ULNRC-04993

**DOCKET NUMBER 50-483
CALLAWAY PLANT
UNION ELECTRIC CO.
REVISION OF REQUEST FOR RELIEF FROM ASME
SECTION XI REQUIREMENTS IN ORDER TO TEMPORARILY
RESTORE WALL THICKNESS OF ASME CLASS 2 CARBON STEEL
MAIN FEEDWATER PIPING BY WELD OVERLAY REINFORCEMENT**

Request to Restore Wall Thickness of ASME Class 2 Carbon Steel Main Feedwater Piping by Weld Overlay Reinforcement

Figure 1: Schematic of Overlay Configuration and Branch Reinforcement.

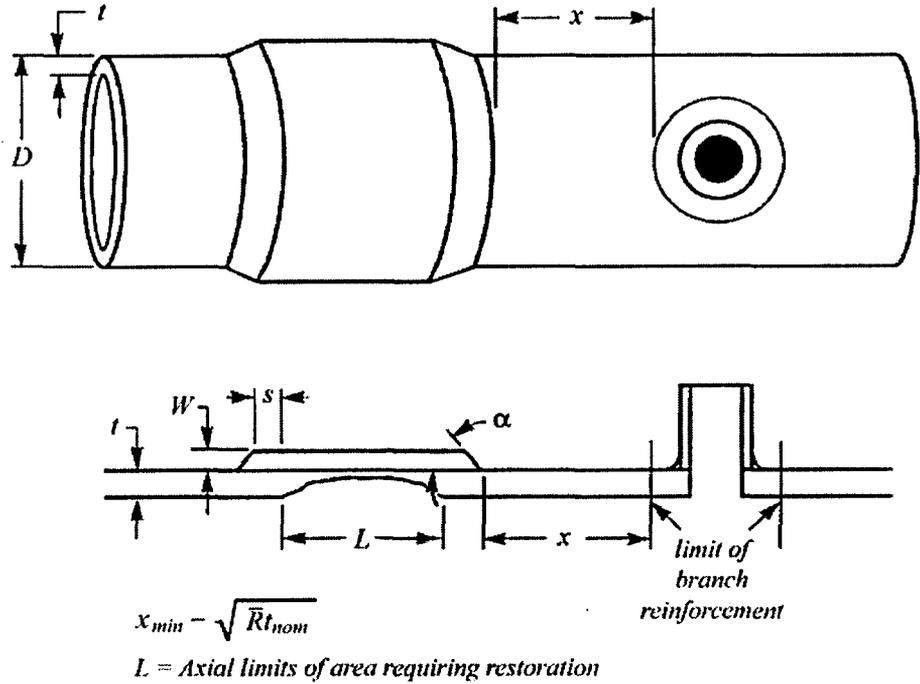
- 3.1. The thickness of the weld overlay reinforcement shall not exceed 1/4 inch. See thickness dimension *W* in Figure 1.
- 3.2. Evaluation of areas that require restoration by weld overlay shall consider the design life of the piping, future internal wall thinning in the weld overlay area, and shall be based on the design thickness as prescribed by ASME Section III ².
- 3.3. The weld overlay shall have a uniform width and extend 360 degrees circumferentially around the piping.
- 3.4. Unless otherwise established by design analysis, the weld overlay shall extend axially a distance of at least *s* in each direction beyond the area that requires restoration, where *s* is defined as:

- 3.5. Edges of the weld overlay shall be tapered to the existing piping surface to a maximum angle of 45°. See angle α shown in Figure 1.
- 3.6. Final configuration of the weld overlay reinforcement shall permit nondestructive examination as required in 5.1 and 5.2.
- 3.7. Except for the tapered edges, the weld overlay reinforcement shall have a uniform thickness.
- 3.8. Tensile strength of the weld filler metal used for the overlay shall be at least that specified for the piping base material.

Figure 2: Drawing M-23AE04 Main Feedwater

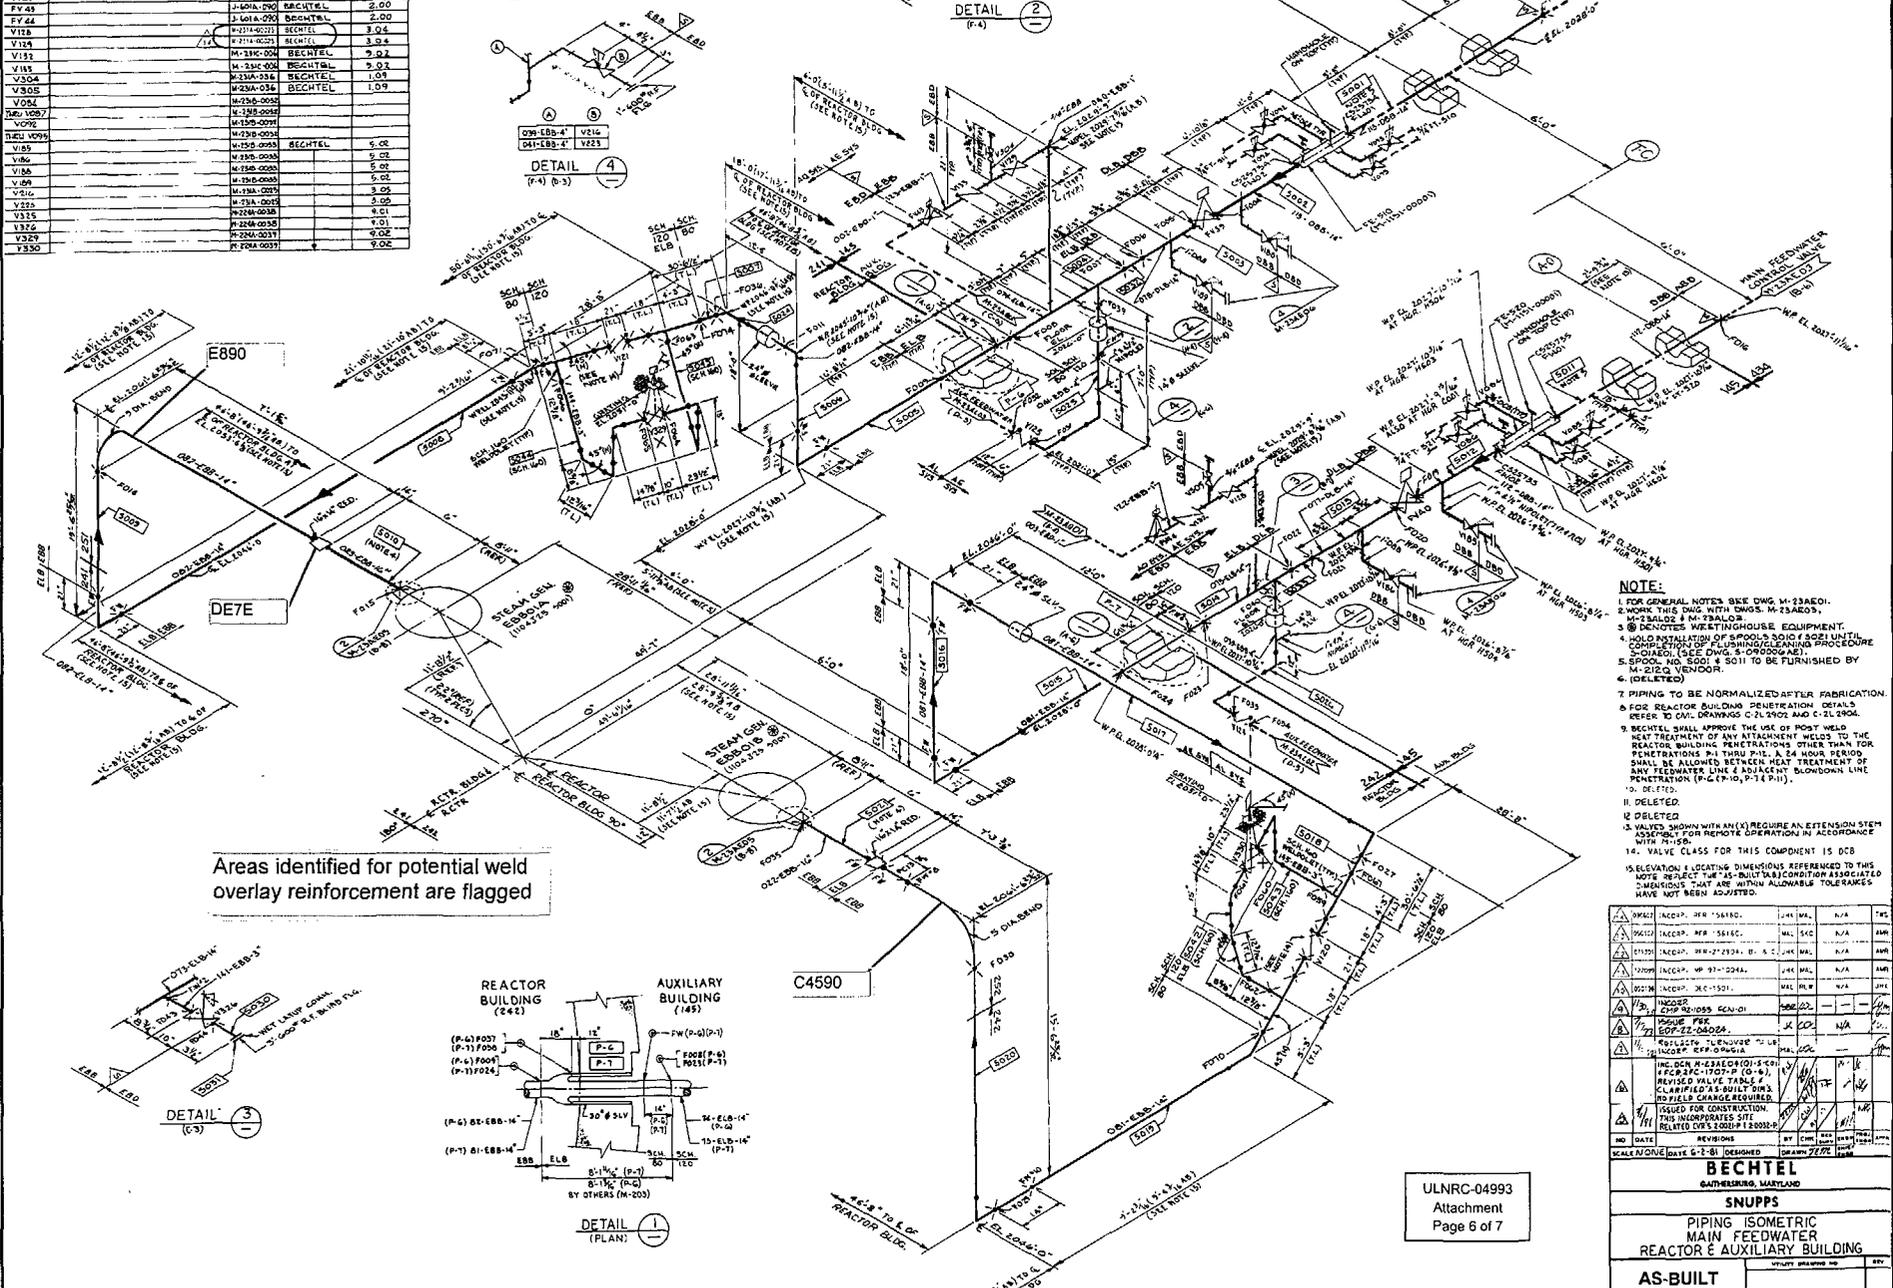
1. Listed FAC ID Numbers are those currently identified in the Callaway FAC Program.
2. Figures 2 and 3 show location of areas by FAC ID No.
3. NPS is pipe size of area for weld overlay reinforcement.

Areas identified for potential weld overlay reinforcement are flagged
